Item 5.**Development Application: 5 Victoria Road, Glebe - D/2021/865****File No.:** D/2021/865**Summary**

Date of Submission:	30 July 2021 Amended plans received 28 March 2022
Applicant:	Weir Phillips
Architect/Designer:	Weir Phillips
Owner:	P L Lavier
Planning Consultant:	PCN Urban
Heritage Consultant:	Weir Phillips
Cost of Works:	\$1,953,198
Zoning:	The site is located within the R1 – General Residential zone. The proposed use of the site comprising multi-dwelling housing is permissible with consent.
Proposal Summary:	<p>The application seeks consent for residential alterations and additions to an existing dwelling house, demolition of outbuildings, and construction of a new dwelling at the rear of the site, resulting in a total of 3 self-contained dwellings on site; two dwellings within the existing building, and a third at the rear of the site.</p> <p>Works include alterations to the existing dwelling on site comprising a new open plan living area at ground level; alterations to the lower ground level to create a second self-contained dwelling; demolition of the existing stables structure on site; and the construction of a new predominantly single storey dwelling with a lower

Figure 45: Maximum height proposed

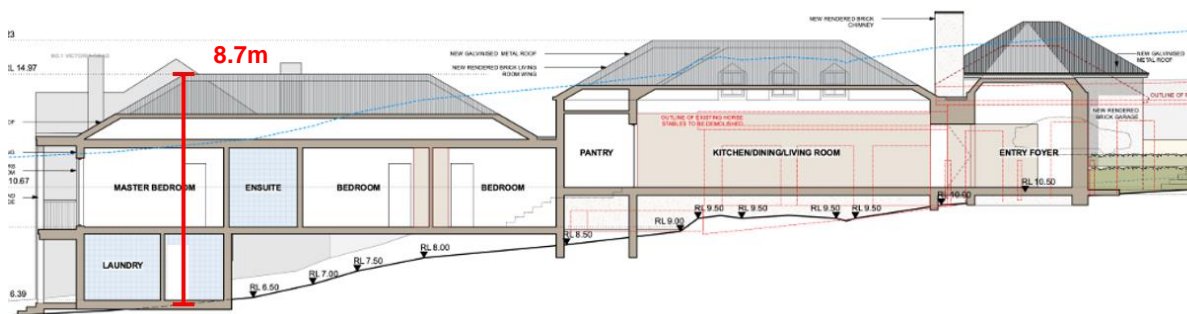
- 37. The site is subject to a maximum height control of 6m. The proposed development has a maximum height of 8.7m, consisting of the roof ridge of the new dwelling (Dwelling 2). The proposal comprises a 45% breach of the height standard.
- 38. It is noted the existing building on site (Dwelling 1) has a maximum height of approximately 10m to the top of the roof ridge, which represents a 66.6% exceedance. See Figure 45 below demonstrating the point of the maximum height breach.

Figure 51: Detail of north-east elevation showing outline of stables building in red dash and extent of new development above the existing roof height of the stables. Maximum height breach of foyer roof circled in pink; breach of middle roof circled in green.

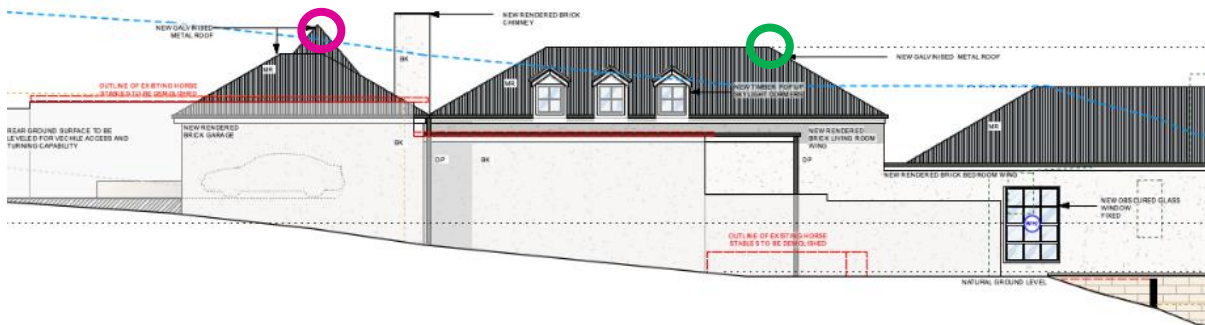
- (f) The north-east elevation drawing below (Figure 51) includes the outline of the stables building to be demolished, shown in a dashed red line. At its highest points (to the apex of the roof above the entry foyer, and to the roof ridge of the middle portion of the house), the new building and roof extend around 2.6m above the roof height of the existing stables structure. The proposed chimney extends approximately 3.2m in height from its junction with the roof below, however it is noted that the LEP definition of building height excludes chimneys.
- (g) With regard to exceedance of the height standard in areas suggested as contributing to view loss, given the natural slope of the land, the breaches are as follows:
 - (i) 450mm from the apex of the roof of the foyer (7.5% breach); and
 - (ii) 1200mm from the apex of the roof ridge of the middle portion of the building (20% breach).

- (h) Figure 51 suggests around 2-2.5m of space above the roof of the stables will comprise of roofscape. This will likely obstruct sightlines to Jubilee Oval currently available to the rear of 14 Alexandra Road.

Figure 53: South-east (facade) elevation of Dwelling 2, showing roof ridge's minor exceedance of 6m height control. Noting chimneys are excluded from building height.

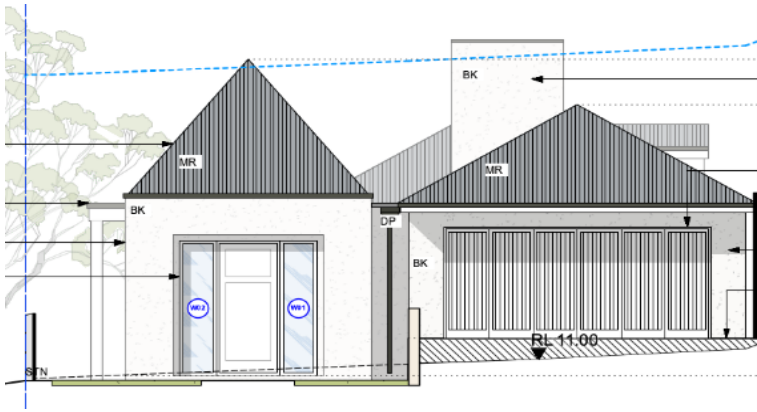
- (l) The proposal complies with the LEP’s FSR standard but breaches the height control. Tenacity states that “where an impact on views arises as a result of non-compliance with one or more planning controls, even a moderate impact may be considered unreasonable.”
- (m) The maximum height breach of 2.7m or 45% is a direct result of the design of Dwelling 2 – in particular, its roofing. The pitched, hipped design of the roof proposed ensures the development respects and is sympathetic to its highly prominent context adjacent to Jubilee Park and within the Toxteth heritage conservation area. It is noted that given the slope of the site, only 600mm to 1200mm (7.5% and 20% exceedances respectively) of the roofing exceeds the 6m height limit in the area of the development which may impact sightlines.

Figure 54: North-east elevation of Dwelling 1 (right of image) and of No. 3 Victoria Road (left of image) - W03 identified in red dash

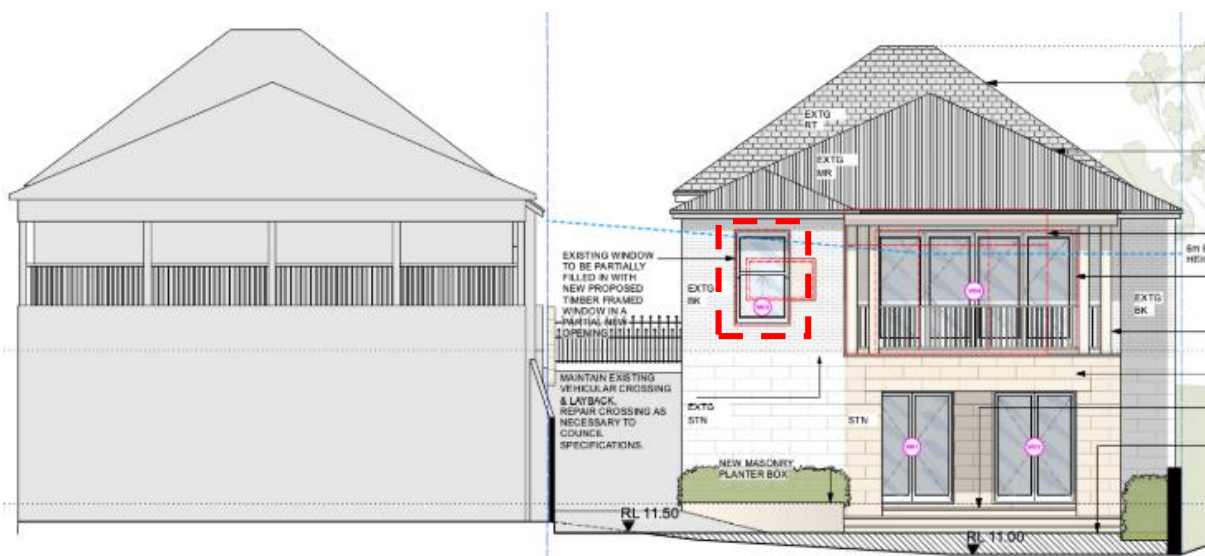
78. Changes to the rear first floor of the existing dwelling (Dwelling 1) include alterations to window W03 to be a vertically proportioned sash window. The window is proposed to have a sill height of 0.7m and is to feature clear glazing. The same change is proposed to W06 on the north-east elevation. See Figures 54 and 55 below.
79. The rear first floor terrace also includes full height glazed bifold doors (W04) to the north-east elevation, and new glazed doors (W03) to the south-west elevation.

Figure 58: W12 shown in red dash, dormer windows shown in blue dash

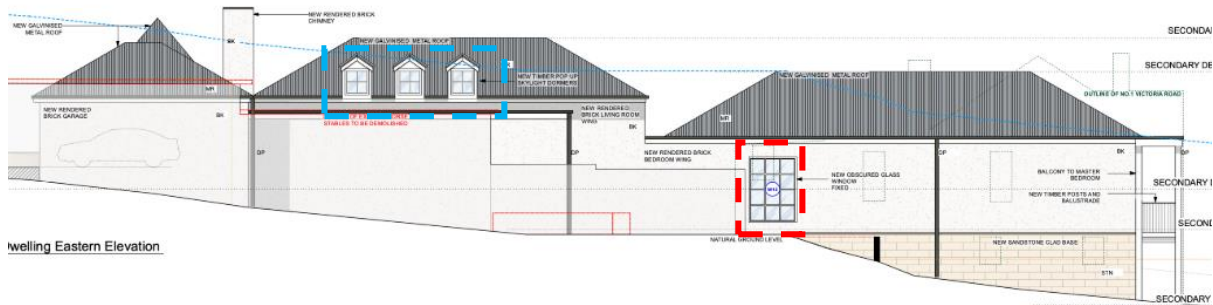
84. The proposal also includes windows to the north-east elevation, including a multi-paned window identified as W12 and three (3) dormer windows. See Figure 58 below.

85. Whilst Council's Urban Designer raised concerns about W12 and its proximity to the kitchen of its neighbour at 1 Alexandra Lane, an annotation on the elevation drawing indicates W12 is proposed to feature obscured glass and is intended to be fixed. The dormer windows are located in the roof of the development, which is single storey in the subject location. There is no means for overlooking to occur from these windows, as their sills are over 3.5m above finished floor level.

Response: As per discussion above in this report, the lower sill of the three windows is 3.5m above finished floor level. The windows as designed will not result in adverse overlooking impacts.

Figure 59: Site plan including trees

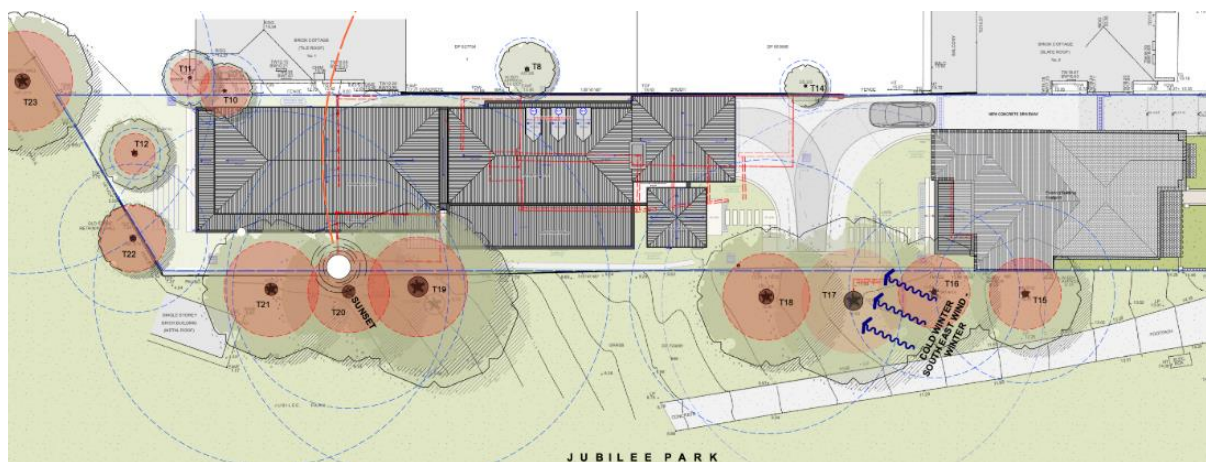
89. Council's tree management officer has reviewed the proposal and made a series of recommendations to ensure trees on site and adjacent are adequately protected, including:

- (e) Provision of a 'Pruning Specification Report' and a 'Work Methodology' based on the most up-to-date plans be submitted, ensuring canopy loss is less than 5% and branches with a diameter greater than 100mm are not proposed to be removed.

92. Tree Management also recommended the inclusion of an advance tree planting condition requiring the planting of three (3) trees that will grow to 10m in height and have a canopy spread of 6m, to meet minimum canopy target requirements contained in Clause 3.5.2 of the DCP.
